ADDENDUM No. 7
TO
CITY OF FRESNO
PUBLIC WORKS STANDARD SPECIFICATIONS
ADOPTED MARCH 4, 1970
RESOLUTION NO. 70-36
UPDATED VERSION APPROVED: DECEMBER 2020 (tentative)
ADMINISTRATIVE DRAFT
for industry review and comment

This addendum is attached to, and made a part of, the above-entitled standard specifications.

The following City Standard Drawings have been amended as indicated below:

CITY OF FRESNO
E-4A

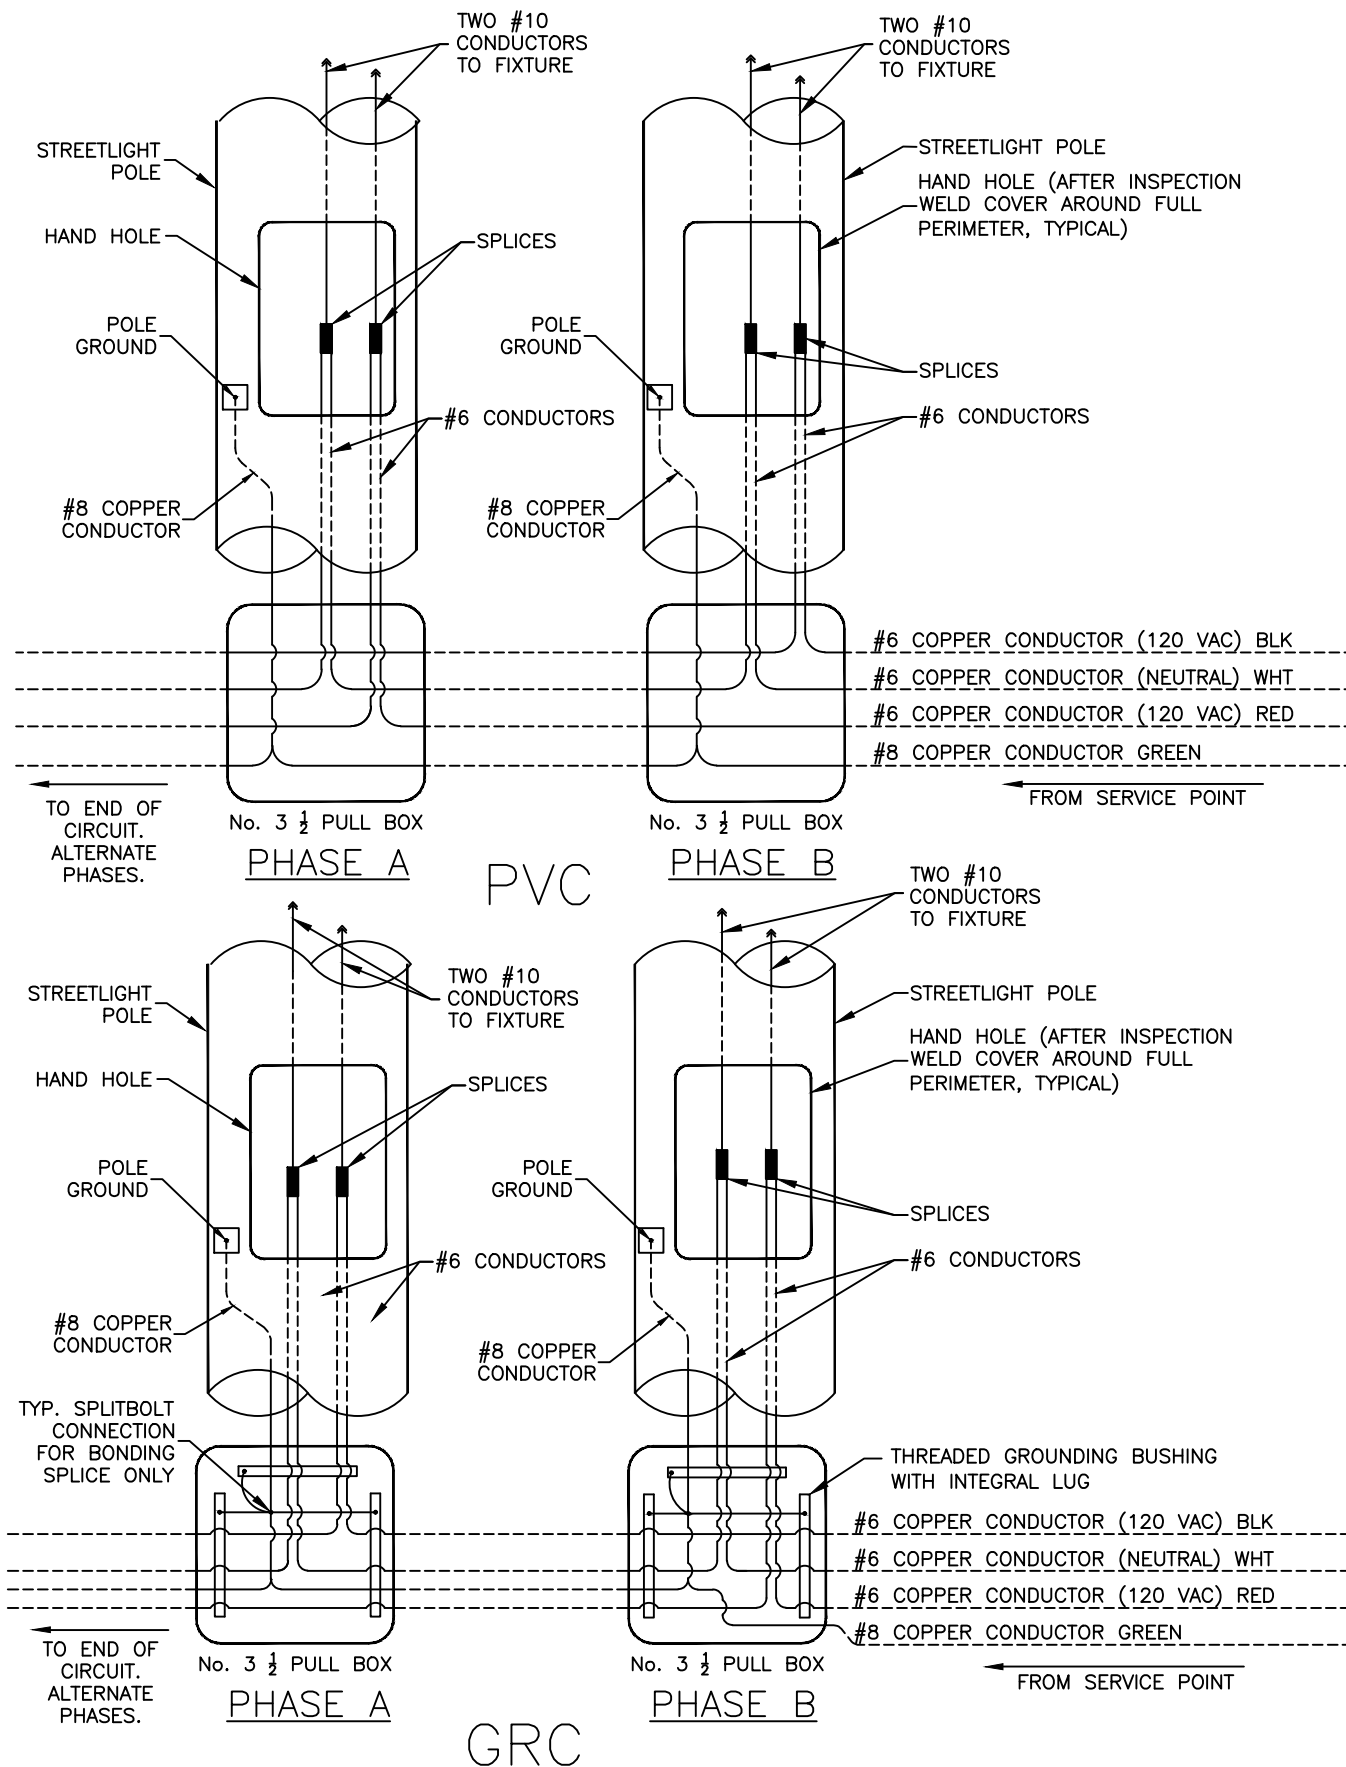
<ol style="list-style-type: none"> 2. Added required thickness to pull box grout. 3. Added Approved Locking Lid per Section 23-1.10 of City Specifications. 4. Note 6: "FUSE AT POINT OF SERVICE SHALL BE 60A IF #6 CONDUCTOR AND 40A IF #8 CONDUCTOR AND SHALL HAVE A TRON HEJ TYPE FUSE HOLDER (SINGLE POLE). INSULATE WIRE CONNECTION SAME AS SPLICES (23-3.12)." Revised to read: "FUSE AT POINT OF SERVICE SHALL BE 60A FOR #6 CONDUCTOR AND SHALL HAVE A TRON HEJ TYPE FUSE HOLDER (SINGLE POLE). INSULATE WIRE CONNECTION SAME AS SPLICES (23-3.12)."
E-5	<ol style="list-style-type: none"> 1. Edits made to wiring diagram to show splices at hand hole. 2. Note was numbered. 3. Note 1: "WITH EXCEPTION OF BONDING JUMPERS, NO SPLICES WILL BE ALLOWED IN PULL BOXES" Revised to read: "WITH EXCEPTION OF BONDING JUMPERS, NO SPLICES WILL BE ALLOWED IN PULL BOXES WITHOUT PRIOR APPROVAL AND THE INSTALLATION OF AN APPROVED LOCKING LID PER SECTION 23-1.10 OF CITY SPECIFICATIONS".

CITY OF FRESNO
RW-6

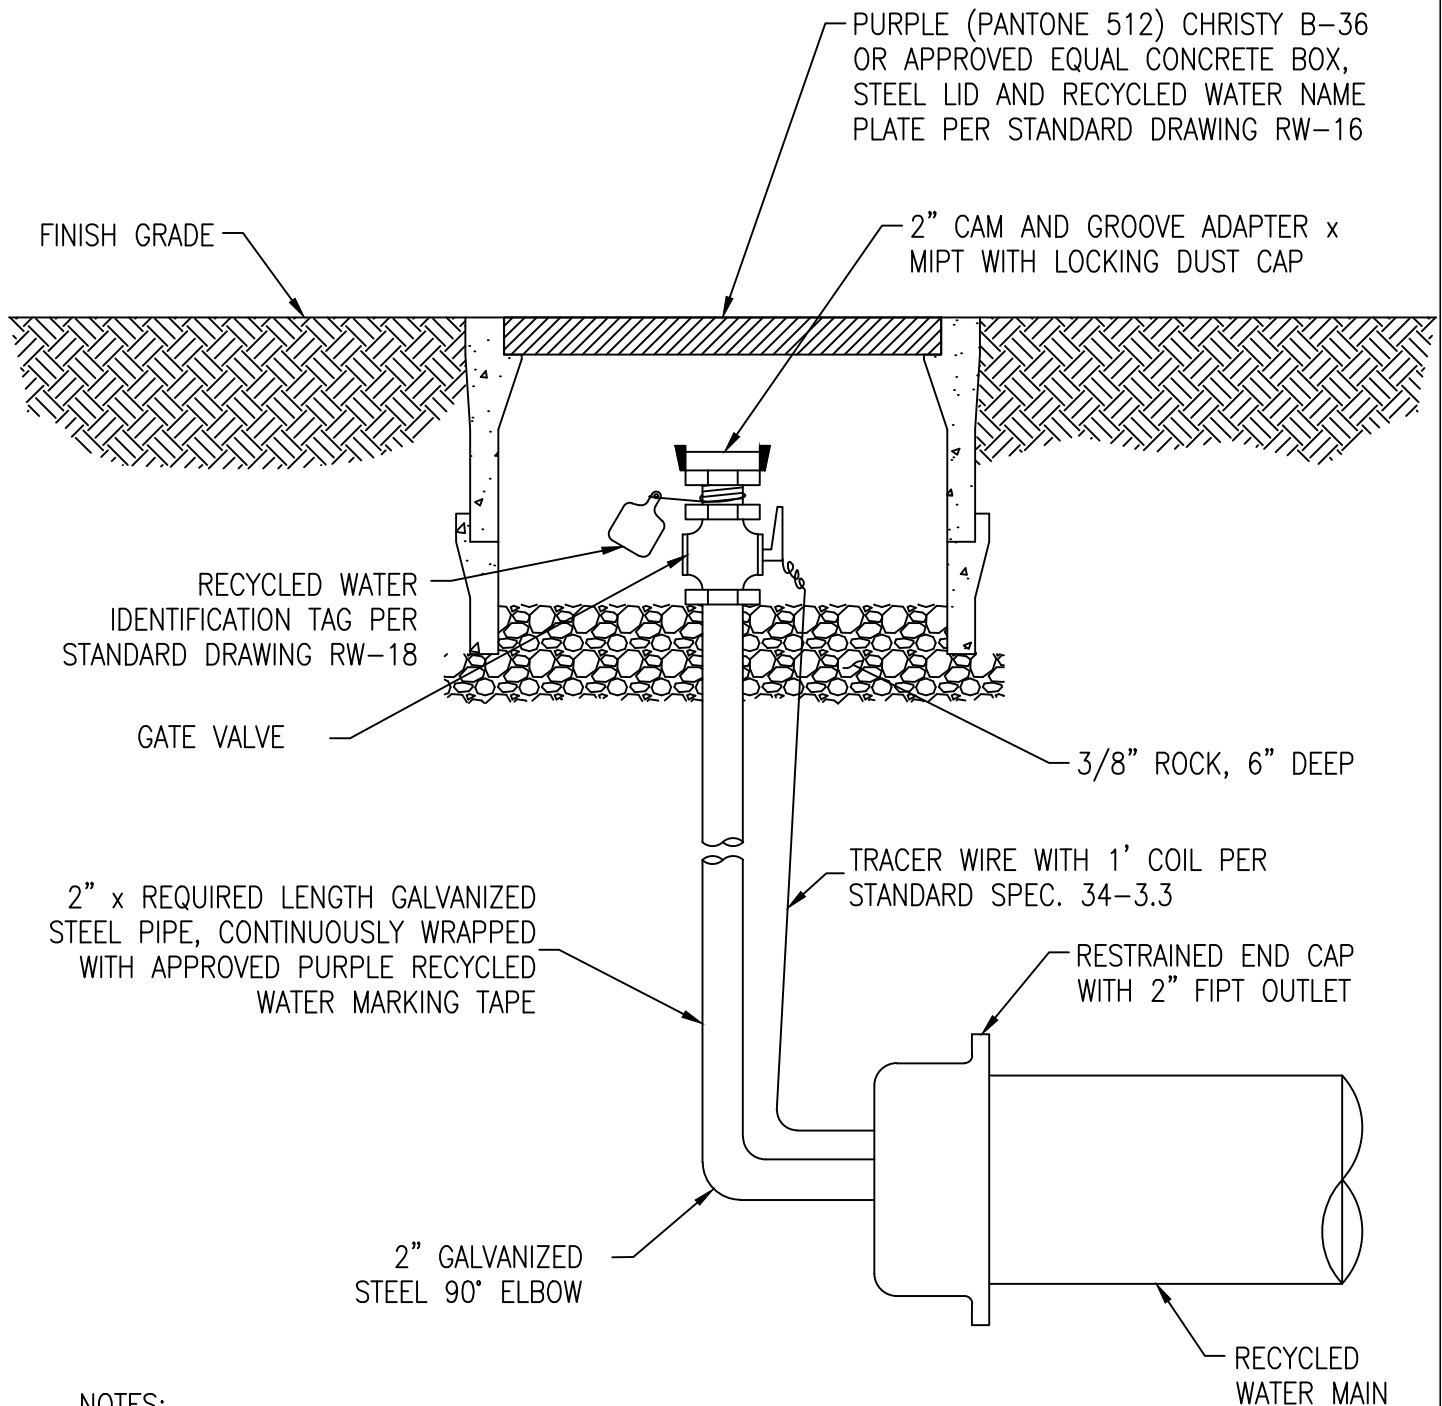
RW-6	<ol style="list-style-type: none"> Drawing name: "4" RECYCLED WATER SERVICE" Revised to read: "4", 6", 8" RECYCLED WATER SERVICE". Callout: "METER BOX WITH ARMORCAST LID WITH CAST IRON READING DOOR; LID SHALL BE PURPLE (PANTONE 512) AND MARKED WITH THE WORDS "RECYCLED WATER" Revised to read: "ARMORCAST POLYMER CONCRETE BOX, A6001460PCX36 AND ARMORCAST LID, A6001456TA-PUR-COF; LID SHALL BE PURPLE (PANTONE 512) AND MARKED WITH THE WORDS "RECYCLED WATER" Drawing Revised: layout of pipes and fittings altered to remove elevation changes and elbows and associated dimensions removed. Drawing Revised: gate valve relocated to behind the meter. Removed callout, "4" PURPLE PVC PIPE". Callout, "PVC OR DUCTILE PIPE CONTINUOUSLY WRAPPED WITH PURPLE TAPE" Revised to read: "4"-6"-8" PVC OR DUCTILE PIPE CONTINUOUSLY WRAPPED WITH PURPLE TAPE" Added callout: "RECYCLED WATER METER. SEE NOTES 7-9 FOR METER SPOOL LENGTH" Callout: "TRACER WIRE WITH 1' COIL PER STANDARD SPEC. 22-3.3" Revised to read: "TRACER WIRE WITH 1' COIL PER STANDARD SPEC. 34-3.3" Added dimension, "30""from top of meter box lid to top of pipe Added Note 7, "FOR 4" RECYCLED WATER SERVICE, METER SPOOL LENGTH SHALL BE 13 ¾" Added Note 8, "FOR 6" RECYCLED WATER SERVICE, METER SPOOL LENGTH SHALL BE 17 ¾" Added Note 9, "FOR 8" RECYCLED WATER SERVICE, METER SPOOL LENGTH SHALL BE 24". Added Note 10, "METERS DEEPER THAN 30 INCHES TO TOP OF PIPE MUST BE RAISED TO 30 INCHES" Added Note 11, "WHEN CURB EXISTS, SET METER BOX 2" TO 6" FROM BACK OF CURB"
